AWB 25-10 Issue 1 - Pacific Scientific rotary seatbelt buckles

AWB 25-10 Issue 1, 3 April 2006

The following figure depicts the Pacific Scientific rotary seatbelt buckle:

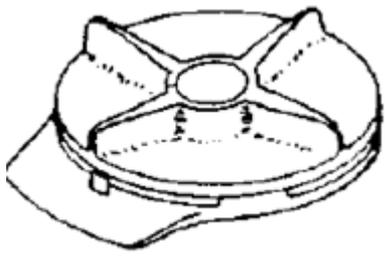
Investigation of a fatal aircraft accident in 2003 showed that the captain had been ejected from her seat upon impact as a result of uncommanded release of a rotary seatbelt buckle which was made by Pacific Scientific. Other uncommanded releases of the same type of rotary seatbelt buckle have been reported.

As a consequence, and at the request of the Boeing Company and the UK CAA, Pacific Scientific Company have designed and manufactured a replacement rotary buckle which incorporates a protective guard to prevent inadvertent release of the buckle.

If so, in each instance it should be determined whether the new guarded seatbelt buckle, as specified in Pacific Scientific Service Bulletin 1117032-25-02 (which was issued specifically in respect to Boeing aircraft) is fitted. If not, it is strongly recommended that the guarded rotary seatbelt buckle, as specified in the above Service Bulletin, be fitted in each instance.
